Design & Place SEPP EIE

UDIA Response

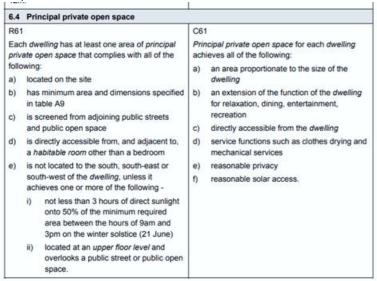
The use of terminology in *Figure A2* is concerning. We note:

- 1. "place" is the outcome, not the starting point; the correct term would be "context";
- 2. "Structure", "Grain" and "Form" are all one and the same component. More appropriate headings might be: Context & Country; Land Use Arrangement (housing, employment, retail etc.); Infrastructure; and Implementation.

It is important to agree on the appropriate relationship between the guidance documents. The EIE proposes that the ADG is complemented by, or informs, the UDG. In fact, the relationship is the reverse. Using the ADG as the framework for the UDG inappropriately focuses design from the bottom up, rather than top down in relation to scale. UDIA recommends that the link between the ADG and the UDG should be clarified that the ADG is a component of the UDG, as built form apartments are a component of a larger precinct. See our related comments above under Section 2.1 *Opportunity for a Fresh Approach – Structure on Type within Spatial Context*.
